SFM-2171-00(024) / 107076301

SUPPLEMENT TO SPECIAL PROVISION NO. 907-618-14

PROJECT: SFM-2171-00(024) / 107076301 -- Lamar County

ADDITIONAL TRAFFIC CONTROL SIGNS REQUIRED:

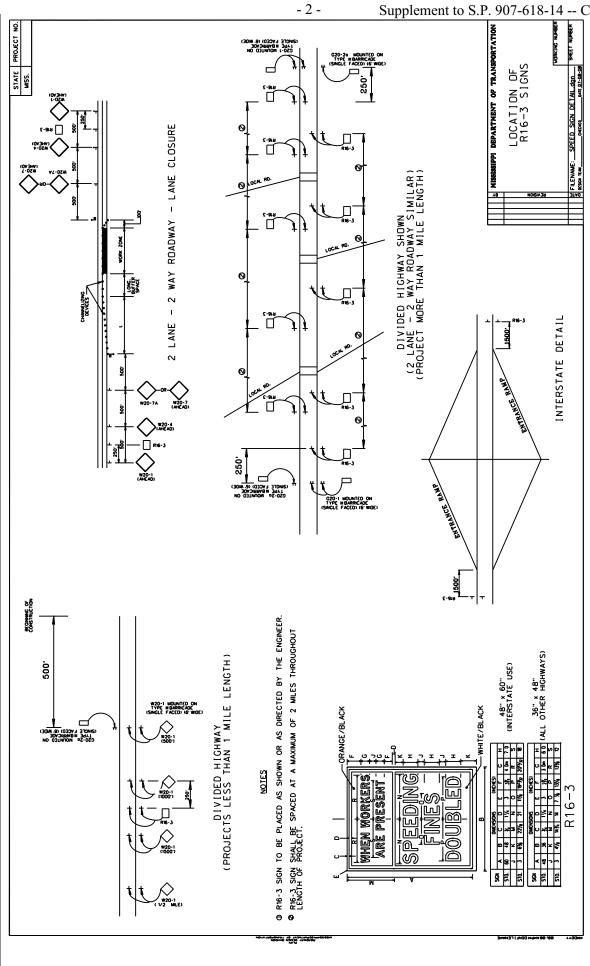
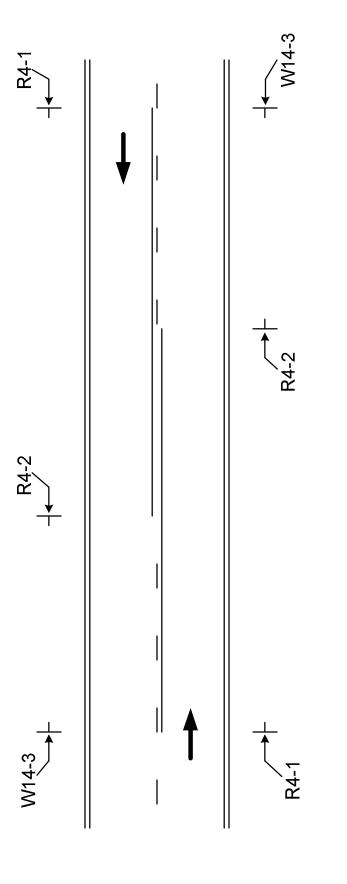
After the first paragraph of Subsection 907-618.01.2 on page 1, add the following.

Additional signs will be required as follows.

- <u>18</u> W20-1 "AHEAD" signs required. One (1) W20-1 "AHEAD" sign is required at each local road or street entering the project.
- **34** R4-1 "DO NOT PASS" signs required.
- 11 R4-2 "PASS WITH CARE" signs required.
- **9** W14-3 "NO PASSING ZONE" signs required.
- 2 R16-3 "SPEEDING FINES DOUBLED" signs required.

R4-1 "DO NOT PASS", R4-2 "PASS WITH CARE", and W14-3 "NO PASSING ZONE" signs are required in accordance with Subsection 618.03.3, this drawing, and as specified in the Manual on Uniform Traffic Control Devices. If no passing zones are 1,000 feet or more, additional "DO NOT PASS" signs shall be installed.

The W14-3, No Passing Zone sign, shall be placed on the left side of the road at the beginning of each no passing zone.

The R4-1, Do Not Pass signs, shall be placed on the right side of the road at the beginning of the no passing zone. Additional R4-1 signs shall be placed right and left in increments of 750 to 1000 feet throughout the length of the no passing zone.

The R4-2, Pass With Care sign, shall be placed on the right side of the road at the end of the no passing zone.
